1 December 2016

RESPONSE TO SUBMISSIONS - Section 96(1a) amendment to SSD 14 6387 at 1 Burroway Road, Wentworth Point

Figure 1: Image of amended café location which illustrates new visual permeability along the through-site link

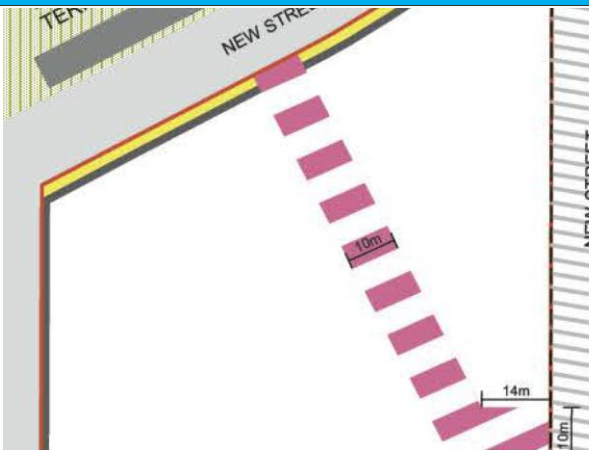
<p>Proposed Café</p> <p>Significant concern is raised with the proposed location of this café. It is a single high structure standing at 3.8m high. It is located at the southern end of the plaza and impedes the visual connection from Burroway Road through the plaza towards the water and the ferry terminal. It also utilises an area which is the gateway to the plaza and impacts upon pedestrian usage (including impeding pedestrian flow). The pedestrian entry to the ferry terminal needs to be clearly defined within the streetscape. It is considered that whilst a café may be an appropriate use within the development site, it should be contained within the ground floor retail component of the development, and not encroach on pedestrian areas. With respect to the above, it is considered that the proposed location of the café does</p>	<p>The proposal has been amended to reduce the café to 30 square metres in area as well as offsetting the café from the through site link in order to maintain a 10 metre dimension for the entirety of the through site link.</p> <p>Therefore, the concerns in relation to visual permeability have been adequately resolved. Furthermore, the café is considered to achieve an important function of activating this gateway area at the entrance to the site which is critical to avoid this large area becoming a sterile space which fails to properly engage with Burroway Road.</p> <p>The amended location of the café complies with the 5 metre setback requirement from Burroway Road and the 10 metre required width of the through site link as prescribed by the SOP Master Plan 2030. The</p>

Issue	Response
<ul style="list-style-type: none"> the current proportions of the proposed cafe are considered to be excessive and should be reduced to a maximum area of 20m². 	 <p>Given that the amended location and size of the café provides the required 10 metre wide through-site link, there is no further basis to warrant a reduction in size to 20 square metres. In particular, it is reiterated that the proposed 30 square metre café will result in a minor increase in the gross floor area to 27,302 square metres and an FSR of 2.62:1 which remains lower than the originally approved gross floor area of the development. Accordingly, the proposed density is within the environmental capacity of the site which has previously been considered to be acceptable by the Department.</p>
City of Parramatta Council	
<p>Proposed Canopy</p> <p>No significant concerns are raised, however it is noted that details of the location of supporting structures have not been provided. In this regard, sufficient pedestrian movement should be maintained throughout the plaza area and appropriate access for people with disabilities will need to be achieved</p>	<p>The canopy is illustrated as being supported by a single row of columns centrally within the through-site link. Given the generous width of the through site link, which is in excess of the minimum required width in the location where the canopy is proposed, it is not considered to result in any meaningful impediment for people with disabilities and in fact provides improved amenity for all pedestrians.</p>

Issue	Response
<p>not provide for an appropriate urban design outcome for the public domain.</p> <p>It is noted that within the Secretary's Environmental Assessment Report for the original application that the SOP Master Plan 2030 applied to the site. It appears that the proposed modification (for the café component) would not comply with the setback and through site link requirements of this master plan. The assessment report also acknowledges the "proposed pedestrian through-site link ... provides direct and obvious access to the adjacent ferry and bus interchange in accordance with SOP Masterplan" which appears to justify the non-compliance with setbacks in the original approval. It is therefore considered that the integrity of the Burroway Road setback and provision of the through site link would be further compromised and contrary to the assessment of the original approval. In this regard, it is considered that the location of the café would not allow for the direct and obvious access to the ferry and bus interchange.</p>	<p>amended location of the café allows for direct and obvious access to the ferry and bus interchange.</p>
